01-Apr-2025 - Redlines - DD

Lot 43 - Duncans Creek
793 Beacon Hill Road
Lillington, NC 27546

PLAN 1
The Clayton - LH
'FRENCH COUNTRY'
ELEVATION

Cover Sheet 'French Country'

Crawl Foundation 'French Country'

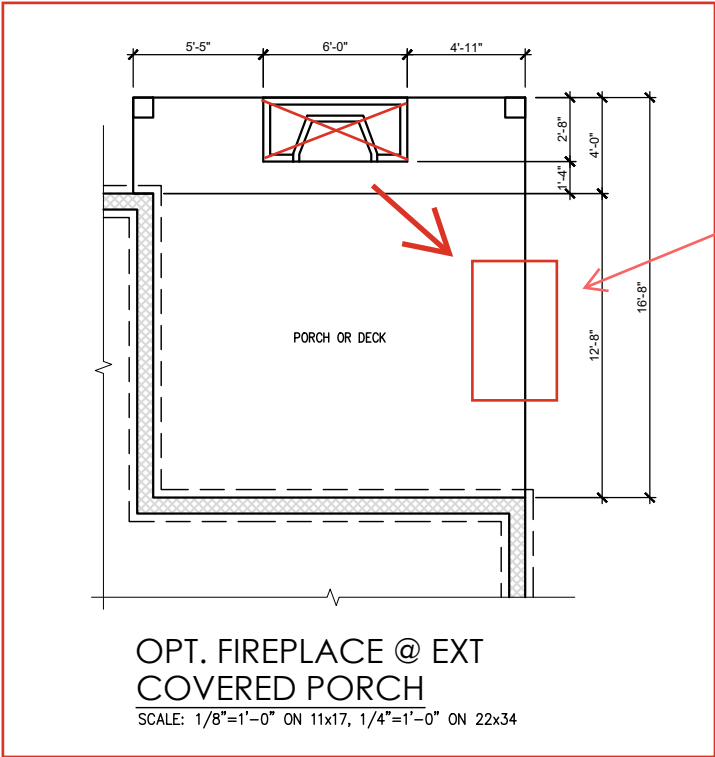
Fireplace on side

OPT. FIREPLACE @ EXT
COVERED PORCH

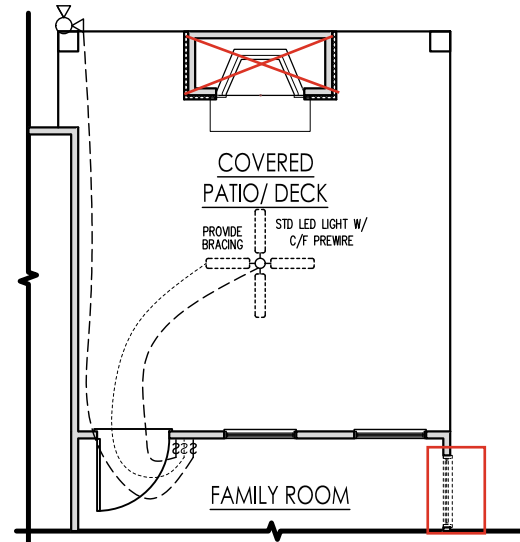
Fireplace moved to
side

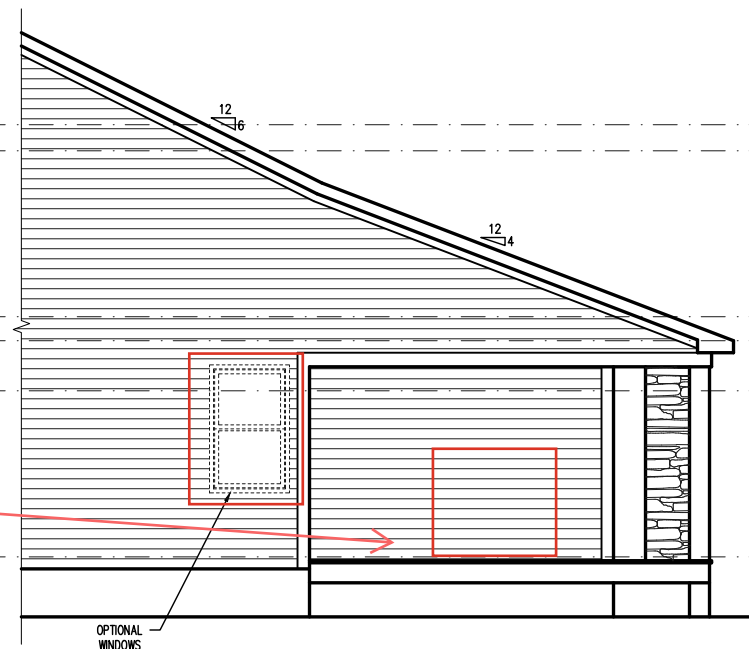
Side Fireplace
